Consumer Products

Service Information

Factory: John Deere Horicon Works

TR800 CLUTCH BUSHINGS

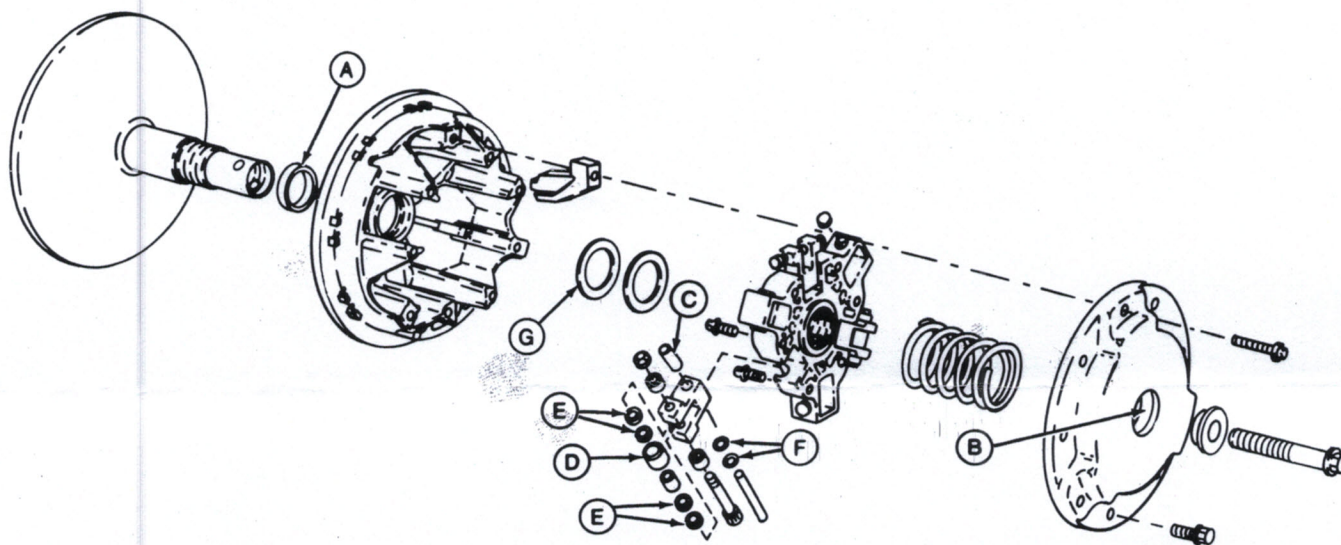
M69328 roller arm loose and/or poor clutch performance.

Moveable sheave bushing M68859 (A) and cover bushing M68862 (B) become loose in their housings and/or wear, causing accelerated wear of the arm roller bushings and their thrust washers.

When replacing arm bushing M69329 (C), roller AM55473 (D), or thrust washers AM55474 (E) and AM55563 (F), always inspect moveable sheave bushing M68859 (A) and cover bushing M68862 (B). Replace bushings if worn, loose, or if staking is not secure. Install larger diameter washer M69706 (G) behind the spider if it has not already been installed.
